PZ&B Staff Combination Memorandum: Landmarks Preservation Commission and Town Council

SUBJECT: COA-24-0004 (ZON-24-0029) 134 SEABREEZE AVE (COMBO)

MEETING: JULY 17, 2024, LPC  
AUGUST 12, 2024, TC

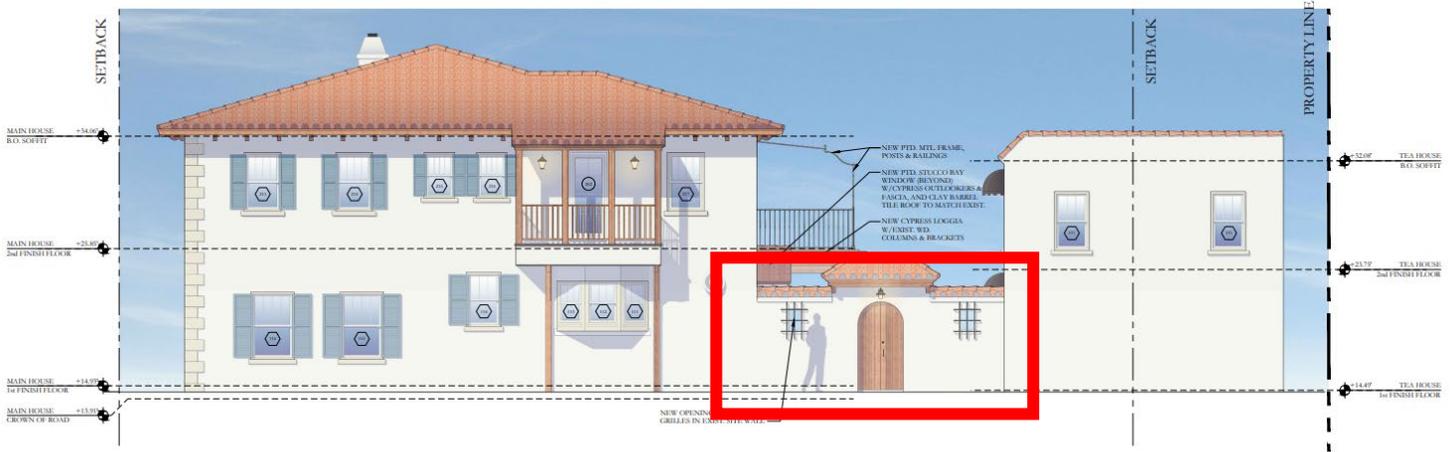
The application proposes several landscape and hardscape modifications. The existing driveway will be resurfaced and expanded. The front walkway will also be resurfaced and will incorporate a new circular feature. In the backyard the existing pool will be demolished and replaced with a new rectangular pool. The existing hardscape in the backyard will be removed and reconfigured with natural stone pavers.

2 WEST ELEVATION PROPOSED  
 1/4"=1'-0"

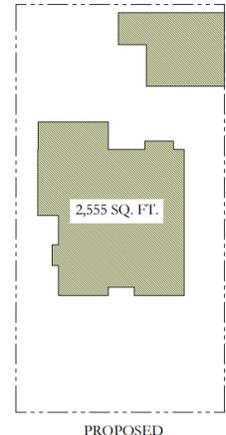
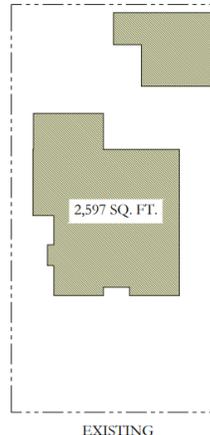
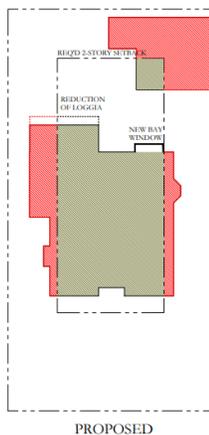
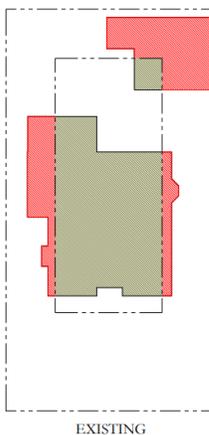
Several windows and doors will also be eliminated or reconfigured. On the north elevation, a door and the associated awning will be removed. On the south side (rear) elevation, all of the first-floor windows and doors will be removed and replaced with new window and door typologies. These changes include a new bay window addition which features a pair of casement windows with sidelights, a circular transom, and paneling beneath. Overall, the windows and doors will have wood frames with divided light patterns.

The new French doors will feature sidelights and a transom with a circular shape. Although the new openings are compatible with the architectural style of the residence, original openings should be retained from a historic preservation perspective. Staff is concerned about the scale of the new arched openings losing the width and rhythm established by the historic fenestration proportions both on the existing rear and its relationship to the front facade.
